# Road Safety Audit Response Report

<b>Report title:</b>	Lye Lane, Bricket Wood, Stage 1 RSA Response
<b>Date:</b>	27/09/22
<b>Document reference and revision:</b>	P2584 Stage 1 RSA Response v1
<b>Prepared by:</b>	Paul Mew Associates
<b>On behalf of:</b>	MRP Planning / JD Rudkin (Builders) Ltd

**Proposed S278 Highway Works**

**Stage 1 Road Safety Audit**

PAUL MEW ASSOCIATES  
 TRAFFIC CONSULTANTS  
 Unit 1, Plym House, 21 Enterprise Way, London, SW18 1FZ  
 Tel: 020 8780 0426  
 E-mail: paul.mew@pma-traffic.co.uk Website: www.pma-traffic.co.uk

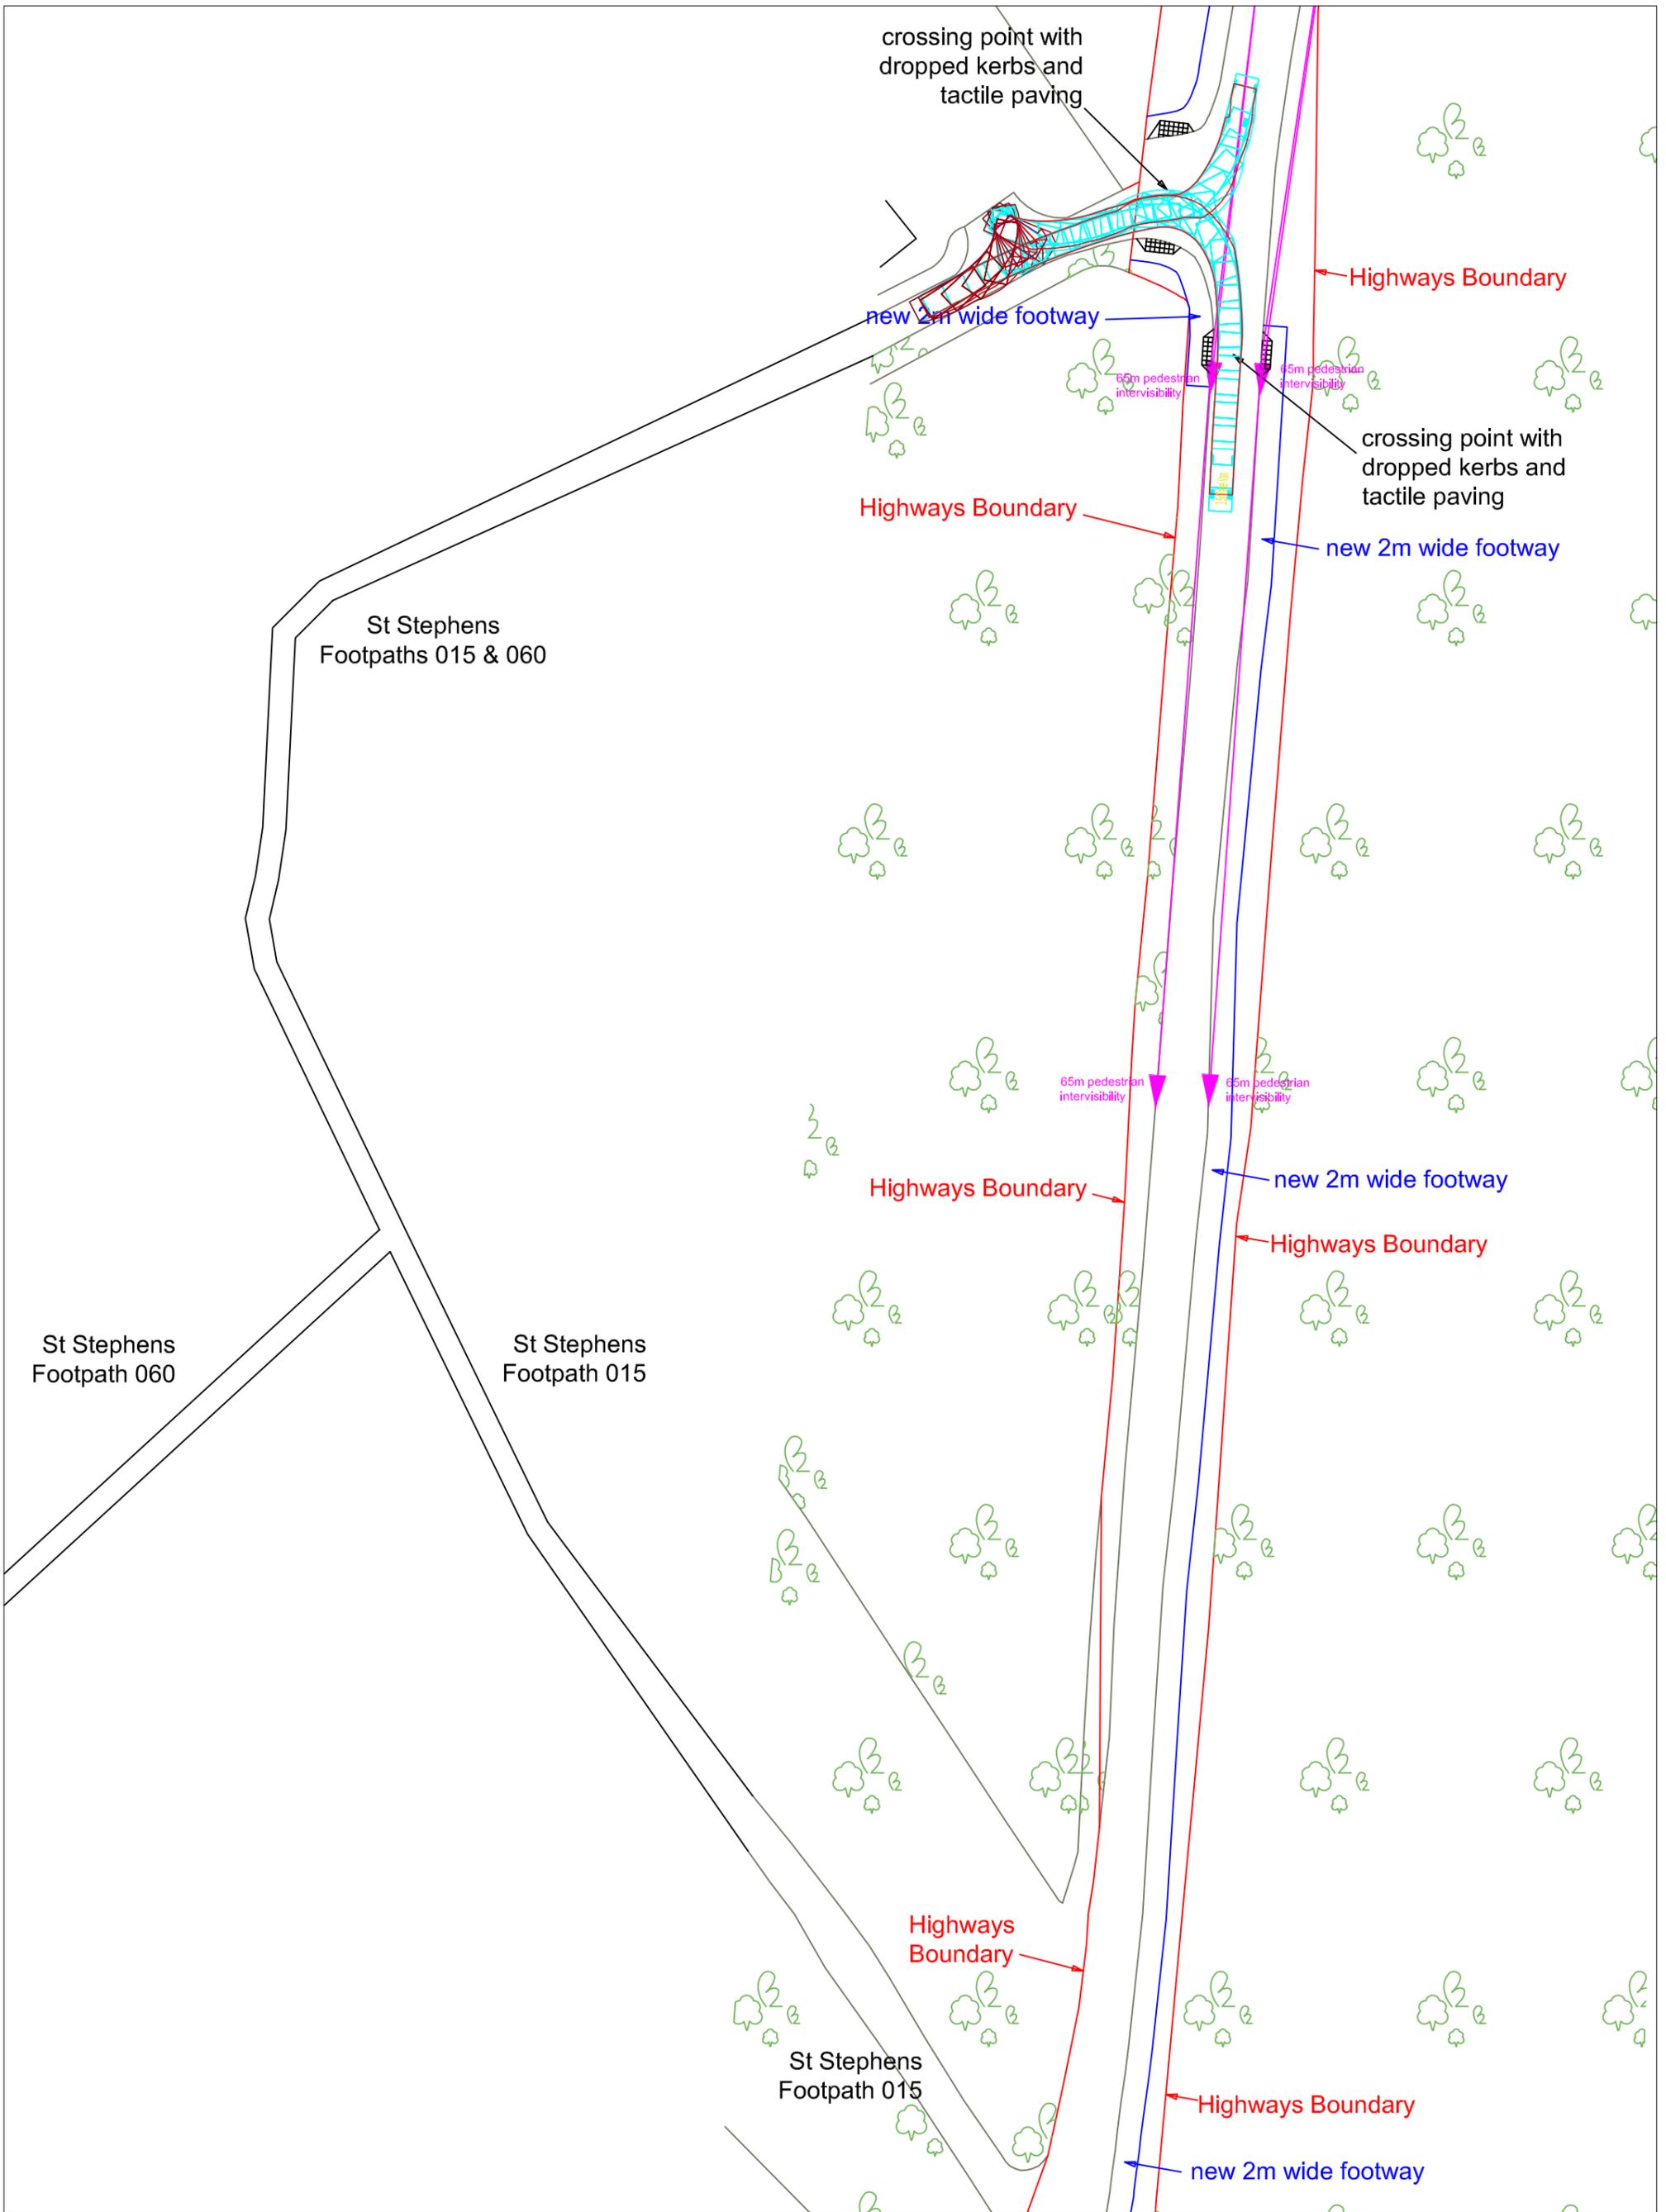
**Locations:** H, I, J, K and L – Crossing provisions south of the proposed development site.

**Summary:** Restricted inter-visibility at the proposed crossing facilities could result in a potential increased risk of vehicular and pedestrian collisions occurring, whereby pedestrians could sustain personal injury.

The site visit has also established the presence of a boundary wall / fence and gate on the northern side of an existing access junction on the western side of Lye Lane, (see Location I within Appendix B), which impacted upon the inter-visibility.

Due to the existing vegetation either side of Lye Lane, concern arises that restricted inter-visibility between pedestrians crossing Lye Lane at these locations and northbound and southbound vehicular traffic could lead to a potential increased risk of vehicular and pedestrian collisions occurring, whereby pedestrians could sustain personal injury.

It is recommended that the inter-visibility at these locations should be accurately measured and kept clear of any impediments that may restrict inter-visibility.

This may necessitate cutting back existing trees, branches and other vegetation on Lye Lane, as well as modifying the crossing provision at the existing access junction on the western side of Lye Lane.

**Location:** P – Lye Lane, reduced footway width.

**Summary:** The proposed narrowed section of footway on the eastern side of Lye Lane could result in a potential increased risk of vehicular and pedestrian collisions occurring, whereby pedestrians could sustain personal injury.

Concern arises that the pedestrians who choose to continue walking on the eastern footway may encounter pedestrians walking towards them on the proposed narrow section of footway, which could result in pedestrians stepping into the mainline carriageway in order to pass one another.

It is recommended that the proposed footway should end to the south of the northern most uncontrolled pedestrian crossing facility, in order to mitigate the above described potential collision scenario.

**Location:** General, throughout the extents of footway provision – Lye Lane, existing ditches.

With the provision of the proposed footways on Lye Lane that would be positioned adjacent to existing verge ditches, concern arises that this situation could lead to a potential increased risk of pedestrian slips and falls occurring into the ditches, especially during the hours of darkness, as Lye Lane is unlit, whereby pedestrians could sustain personal injury.

It is recommended that measures to preclude pedestrians from slipping and falling into the ditches should be provided in order to mitigate the above described potential injury scenario. Measures could include the provision of culverts along Lye Lane or a suitable form of containment fencing to preclude pedestrians from slipping and falling into the ditches.

<p>Locations: H, I, J, K and L – Crossing provisions south of the proposed development site.</p> <p>Summary: Restricted inter-visibility at the proposed crossing facilities could result in a potential increased risk of vehicular and pedestrian collisions occurring, whereby pedestrians could sustain personal injury.</p> <p>The scheme drawing indicates the provision of new footways on Lye Lane between the proposed development site access junction and the junction of West Riding to the south of the proposed development site. The scheme drawing also indicates a number of uncontrolled pedestrian crossing facilities along this section of Lye Lane. The site visit has established there is a notable amount of trees and vegetation either side of Lye Lane between the proposed development site and the junction of West Riding.</p> <p>The site visit has also established the presence of a boundary wall / fence and gate on the northern side of an</p>	<p>It is recommended that the inter-visibility at these locations should be accurately measured and kept clear of any impediments that may restrict inter-visibility. This may necessitate cutting back existing trees, branches and other vegetation on Lye Lane, as well as modifying the crossing provision at the existing access junction on the western side of Lye Lane.</p>	<p>Intervisibility splays will be kept clear of any impediments (planting / vegetation, fencing) over 0.6m above ground level that may restrict visibility at these locations. Pedestrian – vehicle intervisibilities of 65m (in line with 85<sup>th</sup> %ile speeds) can be achieved and are shown in the Revised drawings in Appendix B.</p>

<p>existing access junction on the western side of Lye Lane, (see Location I within Appendix B), which impacted upon the inter-visibility.</p> <p>Due to the existing vegetation either side of Lye Lane, concern arises that restricted inter-visibility between pedestrians crossing Lye Lane at these locations and northbound and southbound vehicular traffic could lead to a potential increased risk of vehicular and pedestrian collisions occurring, whereby pedestrians could sustain personal injury.</p> <p>Additionally, due to the presence of the boundary wall / fence and gate on the northern side of the access junction on the western side of Lye Lane, concern arises that restricted inter-visibility could lead to a potential increased risk of vehicular and pedestrian collisions occurring, whereby pedestrians could sustain personal injury.</p>				
<p>Location: M, N and O – Lye Lane, existing access junction and vehicular crossovers.</p> <p>Summary: Potential swept path requirements of vehicles accessing and egressing the existing access junction and vehicular crossovers on Lye Lane could result in a potential increased risk of vehicular and pedestrian collisions occurring, whereby pedestrians could sustain personal injury.</p> <p>The scheme drawing indicates the provision of new footways on Lye Lane between the proposed development site access junction and the junction of West Riding to the south of the proposed development site. The scheme drawing also indicates a number of uncontrolled pedestrian crossing facilities along this section of Lye Lane. In the event that vehicles overrun the existing verges when accessing or egressing the existing access junction and vehicular crossovers on Lye Lane, concern arises that with the provision of new the footways on Lye Lane this situation could lead to vehicular and pedestrian conflicts occurring.</p> <p>The potential swept path requirements of vehicular traffic accessing and egressing the access junction and vehicular crossovers could result in vehicular traffic overrunning the</p>	<p>It is recommended that swept path analysis exercises should be undertaken for all the expected types and sizes of vehicles using the access junction and vehicular crossovers.</p> <p>Should overrunning of the footways occur, it is recommended that the kerb lines should be modified in order to mitigate the above described potential collision scenario.</p>	<p>Swept path analysis has be undertaken as shown in Appendix B for vehicles turning in / out of the accesses on Lye Lane and demonstrates that they do not over run the proposed footway. It should be noted that swept path analysis has not been carried out for Location N as no vehicle access is provided at this location, rather the location shows a local footpath crossing Lye Lane.</p>

<p>proposed footway areas. As a result, this situation could lead to a potential increased risk of vehicular and pedestrian collisions occurring, whereby pedestrians could sustain personal injury.</p>				
<p>Location: P – Lye Lane, reduced footway width.  Summary: The proposed narrowed section of footway on the eastern side of Lye Lane could result in a potential increased risk of vehicular and pedestrian collisions occurring, whereby pedestrians could sustain personal injury.  The scheme drawing indicates the provision of new 2m wide footways on Lye Lane between the proposed development site access junction and the junction of West Riding to the south of the proposed development site, which include a number of uncontrolled pedestrian crossing facilities. The scheme drawing also indicates a length of footway south of the M25 over-bridge narrows down to 1m before widening out to 2m on the eastern side of Lye Lane.  The site visit has established that there is a vehicle restraint barrier located on the eastern side of Lye Lane south of the M25 over-bridge. Concern arises that the pedestrians who choose to continue walking on the eastern footway may encounter pedestrians walking towards them on the proposed narrow section of footway, which could result in pedestrians stepping into the mainline carriageway in order to pass one another.  The presence of the existing vehicle restraint barrier exacerbates the situation, as the barrier is likely to restrict pedestrians from manoeuvring further east when seeking to pass an opposing pedestrian on this section of footway. As a result, this situation could result in a potential increased risk of vehicular and pedestrian collisions occurring, whereby pedestrians could sustain personal injury.</p>	<p>It is recommended that the proposed footway should end to the south of the northern most uncontrolled pedestrian crossing facility, in order to mitigate the above described potential collision scenario.</p>	<p>The proposed footway has been terminated south of the northernmost uncontrolled pedestrian crossing facility as shown in Appendix B.</p>

<p>Location: General, throughout the extents of footway provision – Lye Lane, existing ditches.  Summary: Location of existing ditches in proximity to the proposed new footways on Lye Lane could result in a</p>	<p>It is recommended that measures to preclude pedestrians from slipping and falling into the</p>	<p>Measures will be provided to preclude pedestrians from slipping and falling into the ditches. These could include the provision of culverts along Lye Lane or other suitable forms of containment fencing.</p>

<p>potential increased risk of pedestrian slips and falls occurring when walking adjacent to existing ditches along Lye Lane, whereby pedestrians could sustain personal injury.</p> <p>The scheme drawing indicates the provision of new footways on Lye Lane between the proposed development site access junction and the junction of West Riding to the south of the proposed development site.</p> <p>The site visit has established the presence of verge ditches running both sides of Lye Lane.</p> <p>With the provision of the proposed footways on Lye Lane that would be positioned adjacent to existing verge ditches, concern arises that this situation could lead to a potential increased risk of pedestrian slips and falls occurring into the ditches, especially during the hours of darkness, as Lye Lane is unlit, whereby pedestrians could sustain personal injury.</p>	<p>ditches should be provided in order to mitigate the above described potential injury scenario.</p> <p>Measures could include the provision of culverts along Lye Lane or a suitable form of containment fencing to preclude pedestrians from slipping and falling into the ditches</p>
